DELAWARE DEPARTMENT OF TRANSPORTATION	ADDENDUMS / REVISIONS		SCALE 0 50 100 150 FEET	SR1 / I-95 INTERCHANGE	CONTRACT 28-090-03	BRIDGE NO.	CONSTRUCTION PLAN	CP-14
	ADDENDUM NO. 3 CHANGED ITEM NO., ADDED O.H. SIGN REMOVAL, 02/18/2011 RLS	ADDENDUM NO. 4 CHANGED ITEM NO., 04/01/2011, RLS			COUNTY NEW CASTLE	DESIGNED BY:		SHEET NO. 78
						CHECKED BY:		TOTAL SHTS. 803

DELAWARE DEPARTMENT OF TRANSPORTATION	ADDENDUMS / REVISIONS: ADDENDUM NO. 4 ADDED REINFORCEMENT, 04/01/11, SAM		SR1 / I-95 INTERCHANGE	CONTRACT 28-090-03	BRIDGE NO. 1-716B	RAMP A OVER I-95 PIER 2 REINFORCEMENT 2
				COUNTY NEW CASTLE	DESIGNED BY: K. D. BEAVER	
					CHECKED BY: R. F. KIRCHNER

CP-13	
SHEET NO.	77
TOTAL SHTS.	803

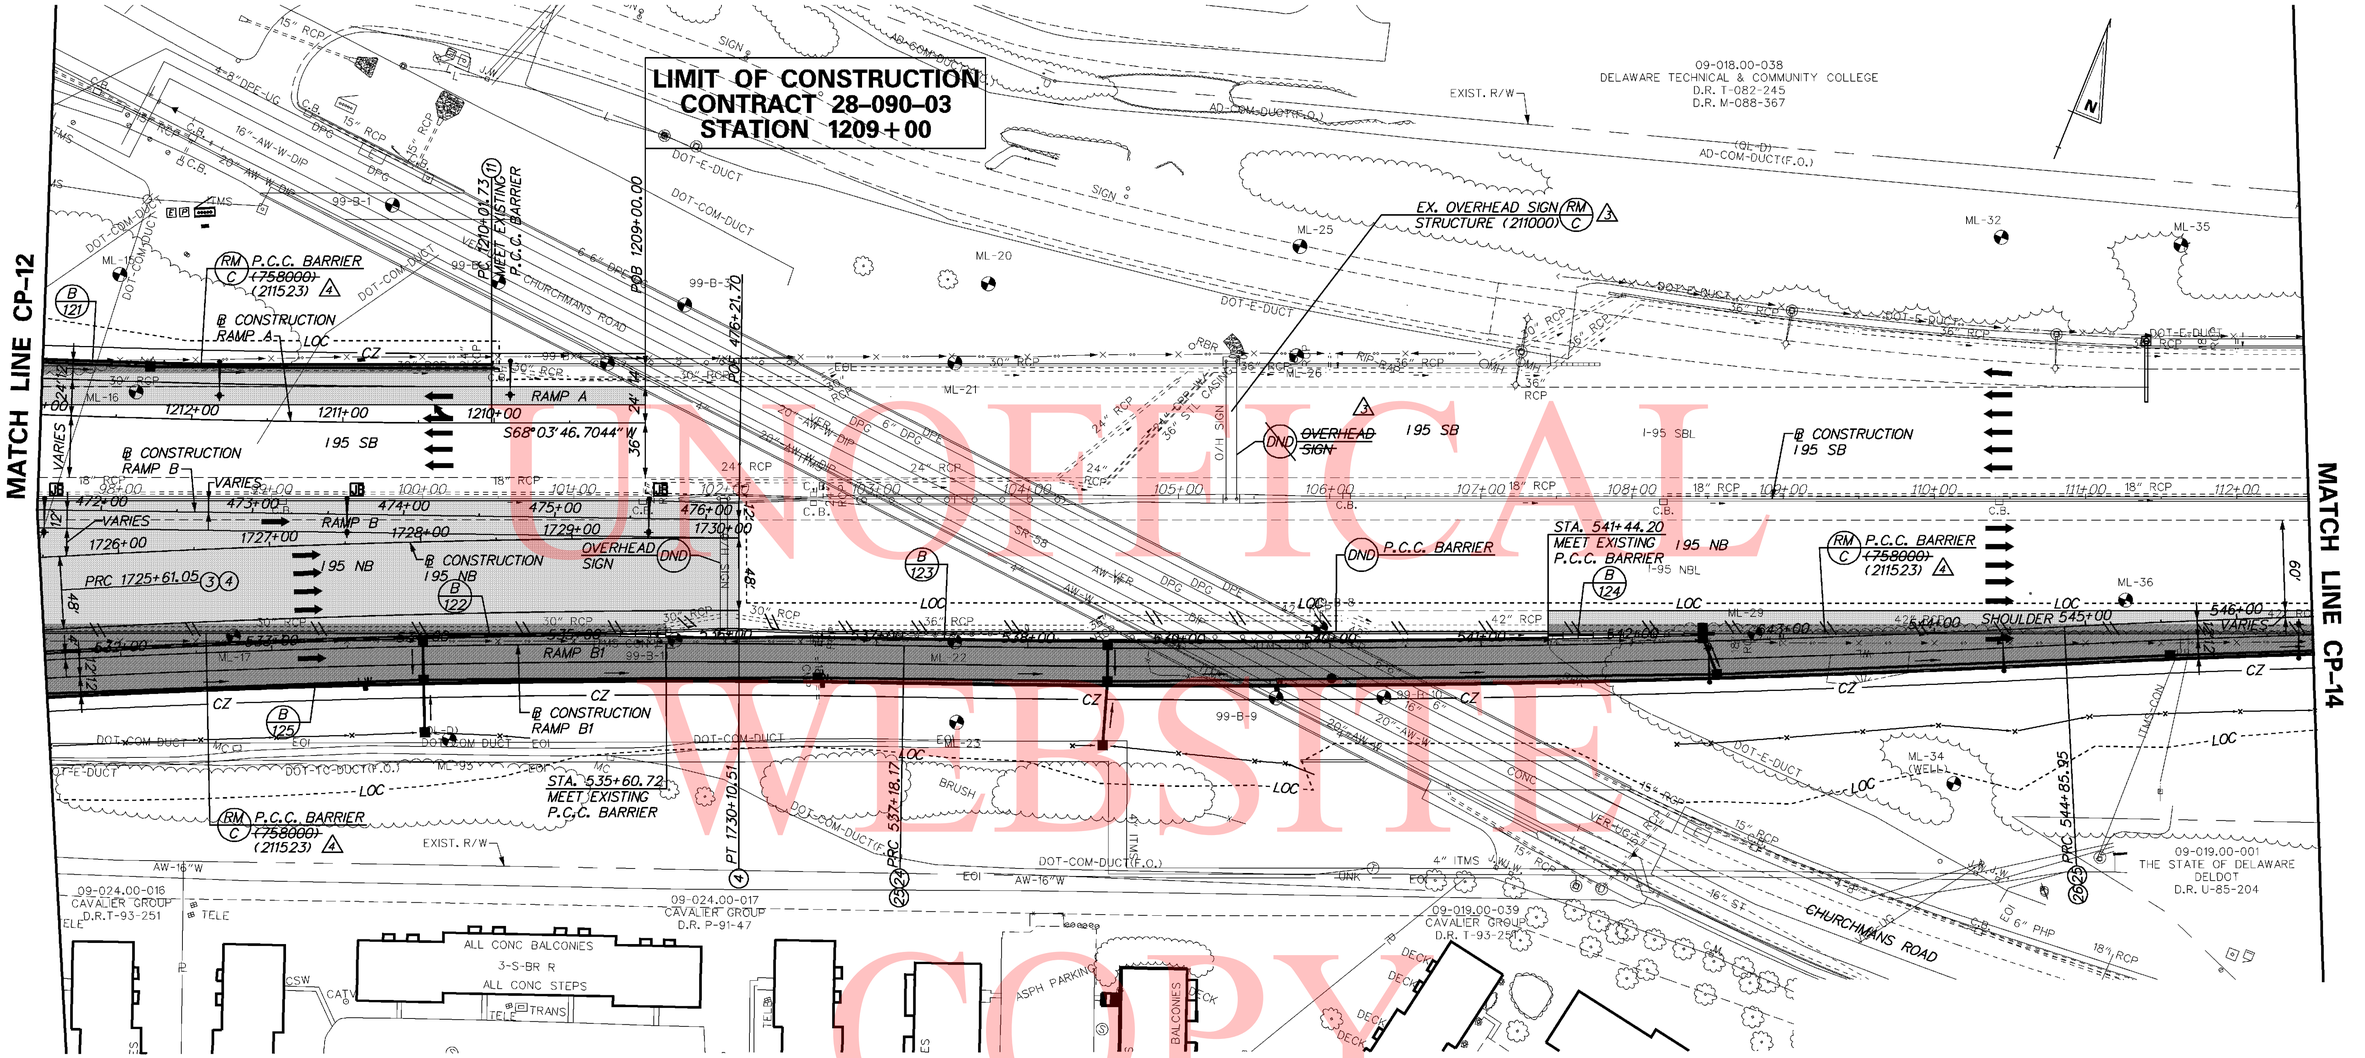
ADDENDUMS / REVISIONS	
ADDENDUM NO. 3 CHANGED ITEM NO., ADDED O.H. SIGN REMOVAL, 02/18/2011 RLS	ADDENDUM NO. 4 CHANGED ITEM NO., 04/01/2011, RLS

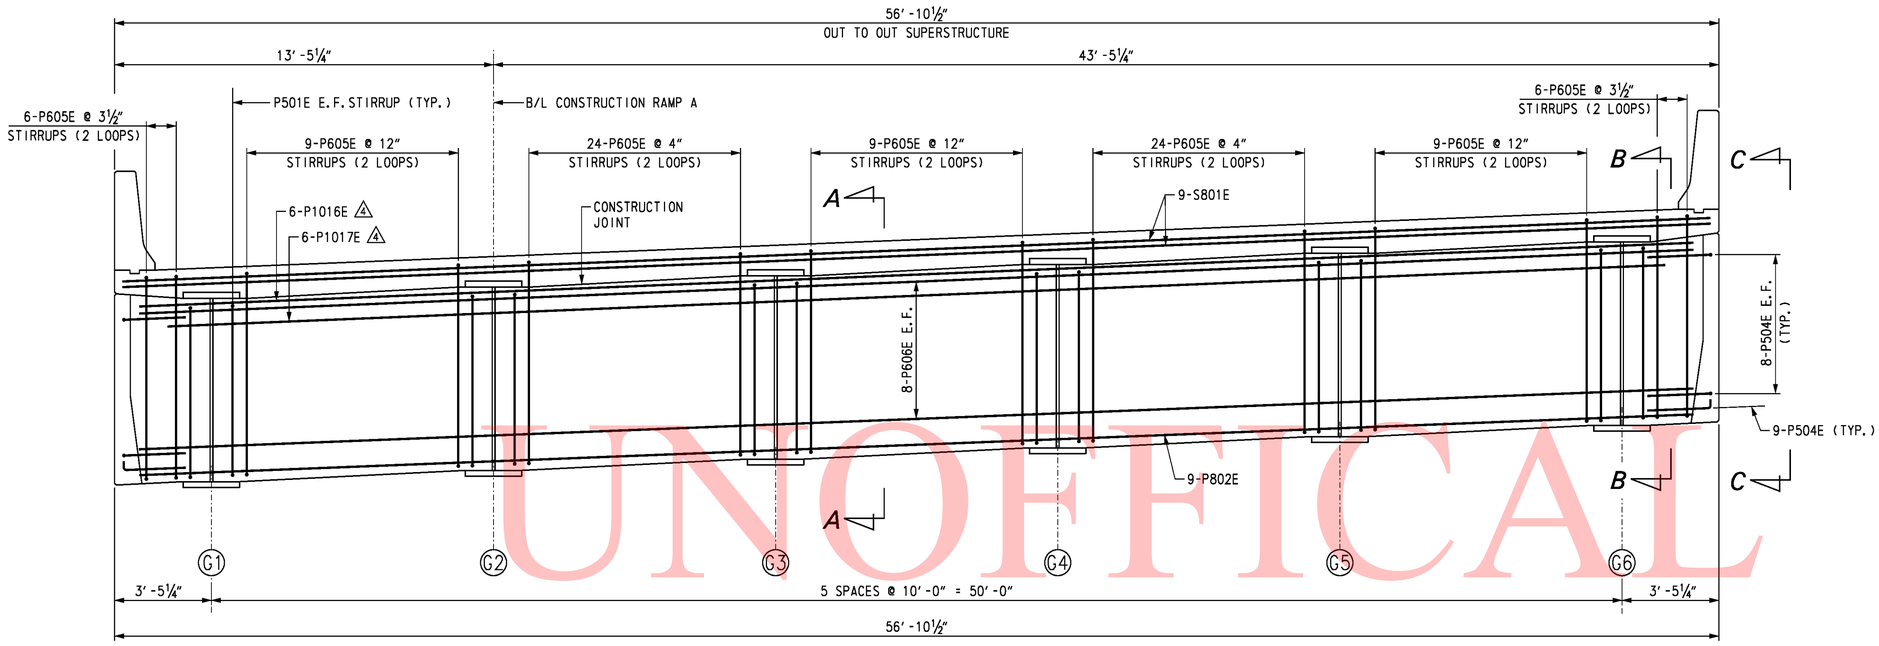
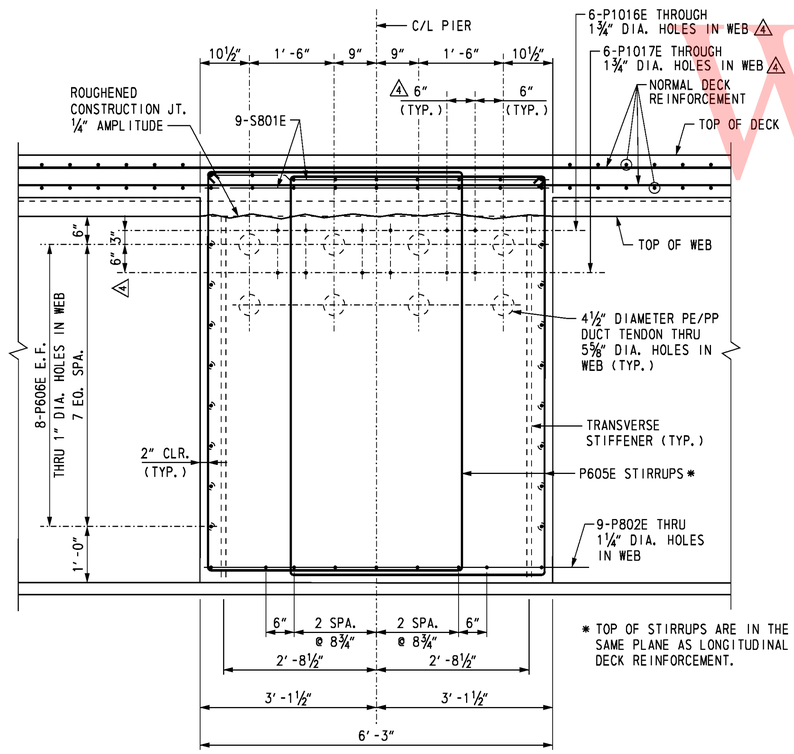
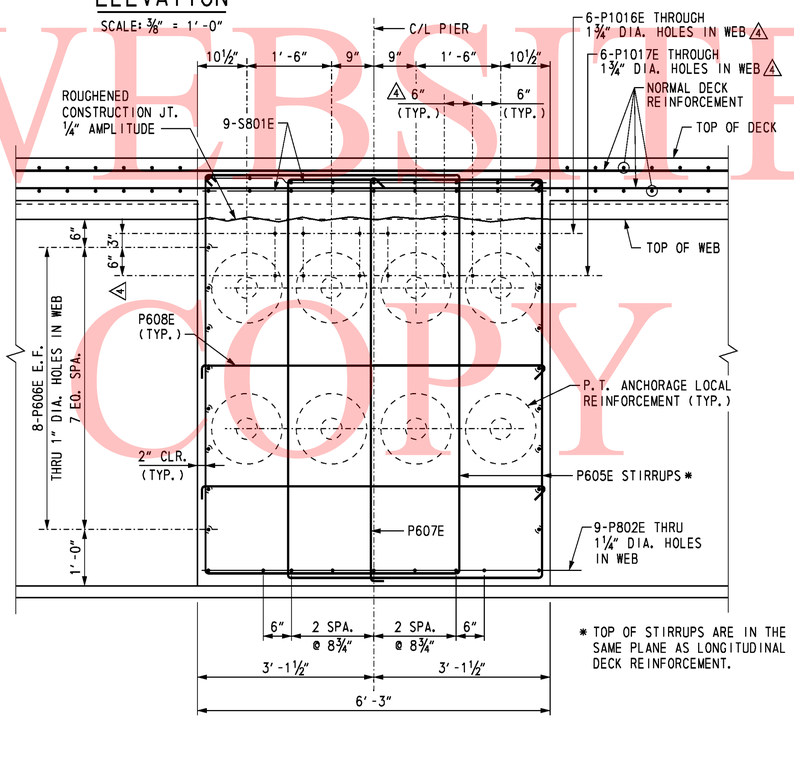
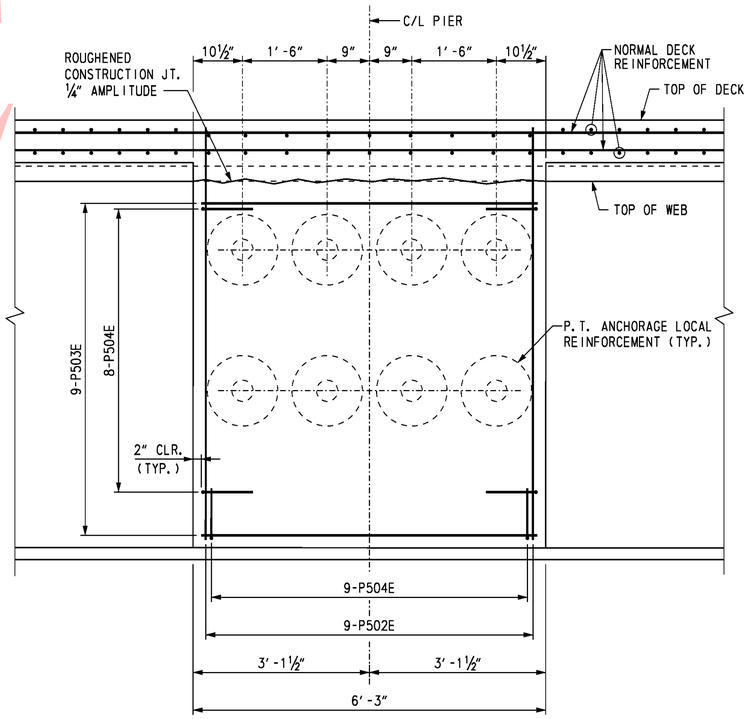
DELAWARE DEPARTMENT OF TRANSPORTATION	ADDENDUMS / REVISIONS ADDENDUM NO. 4 ADDED REINFORCEMENT, 04/01/11, SAM	SR1 / I-95 INTERCHANGE	CONTRACT 28-090-03 COUNTY NEW CASTLE	BRIDGE NO. 1-716B DESIGNED BY: K. D. BEAVER CHECKED BY: R. F. KIRCHNER	RAMP A OVER I-95 PIER 1 REINFORCEMENT 2	S1-21 SHEET NO. 215 TOTAL SHTS. 803

S1-29	
SHEET NO.	223
TOTAL SHTS.	803

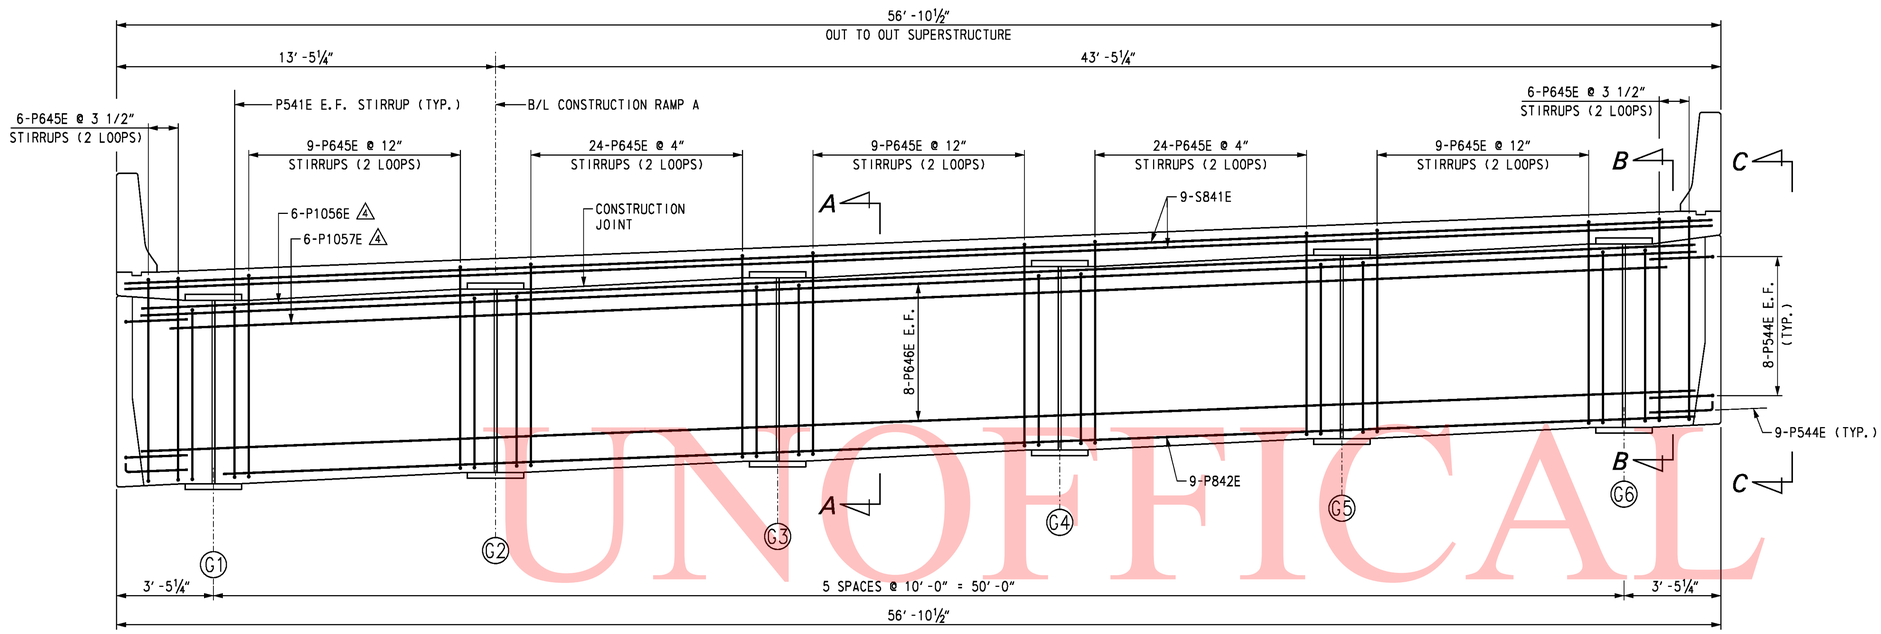
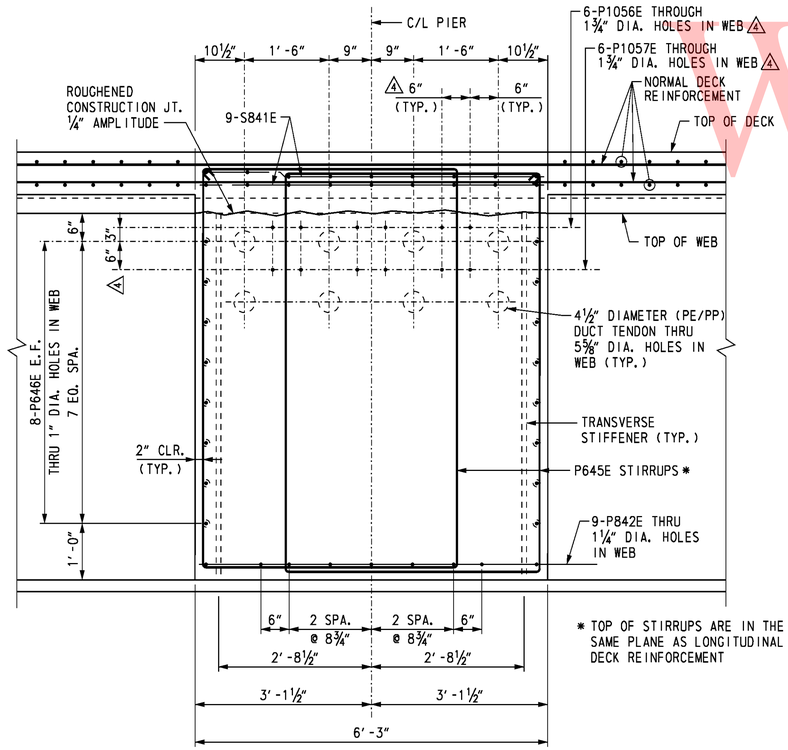
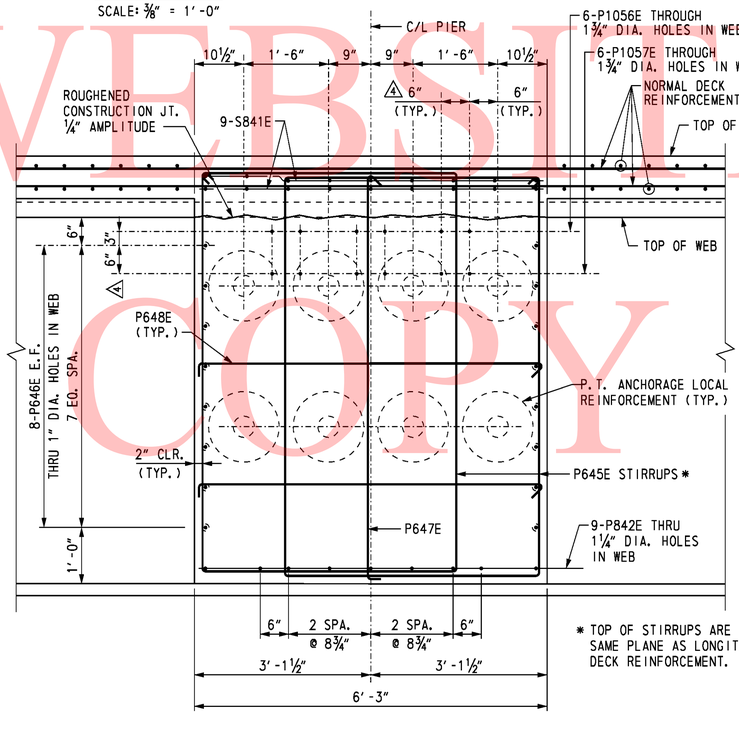
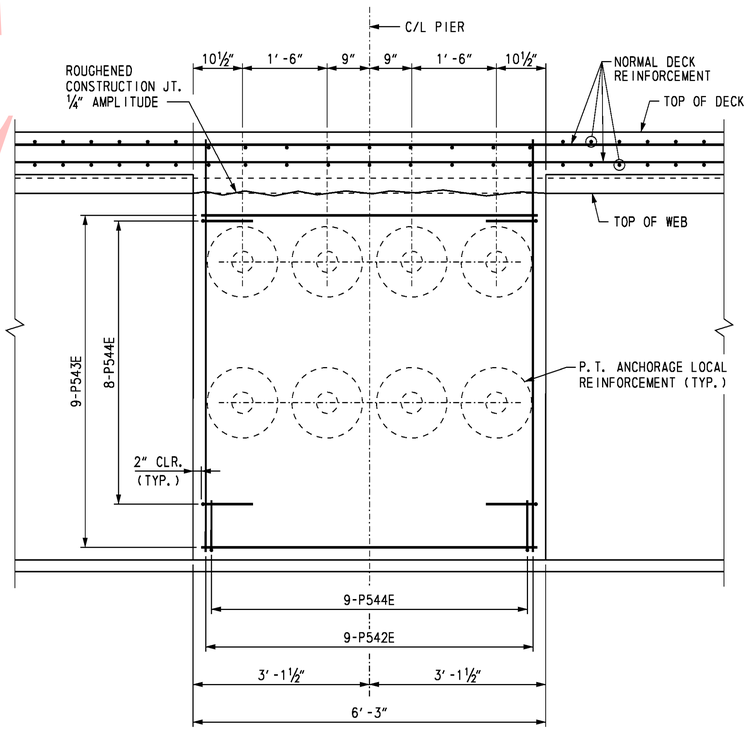
ADDENDUMS / REVISIONS	
ADDENDUM NO. 4 ADDED REINFORCEMENT, 04/01/11, SAM

RAMP B OVER I-95NB
FIXED BEARING DETAILS

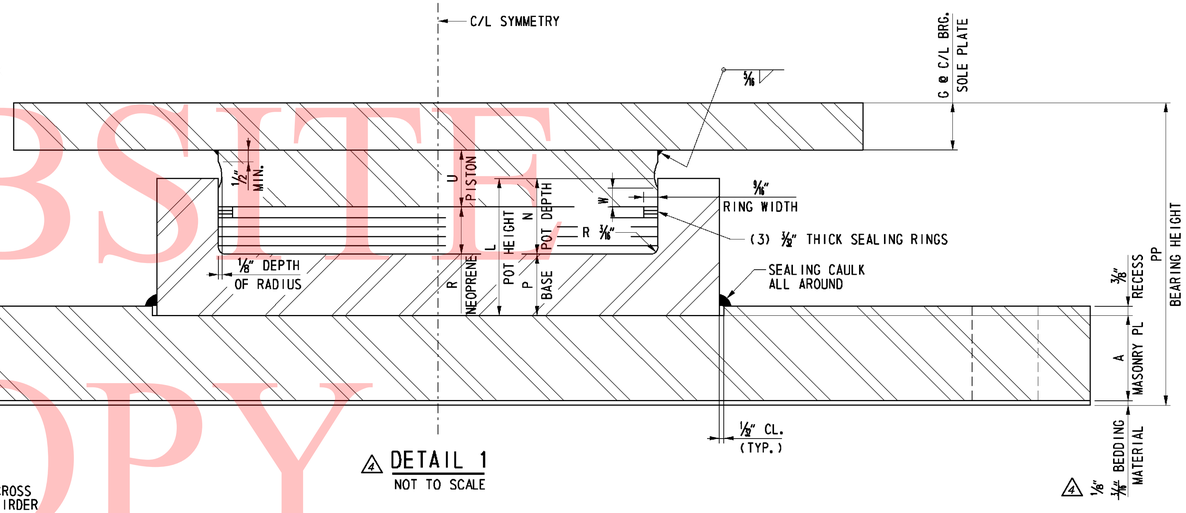
ADDENDUMS / REVISIONS
ADDENDUM NO. ⚠4, BEARING DIMENSIONS, SIDE VIEW, ELEVATION, DETAIL 1, SECTION B-B, ANCHOR ROD, 04/01/11, DWD
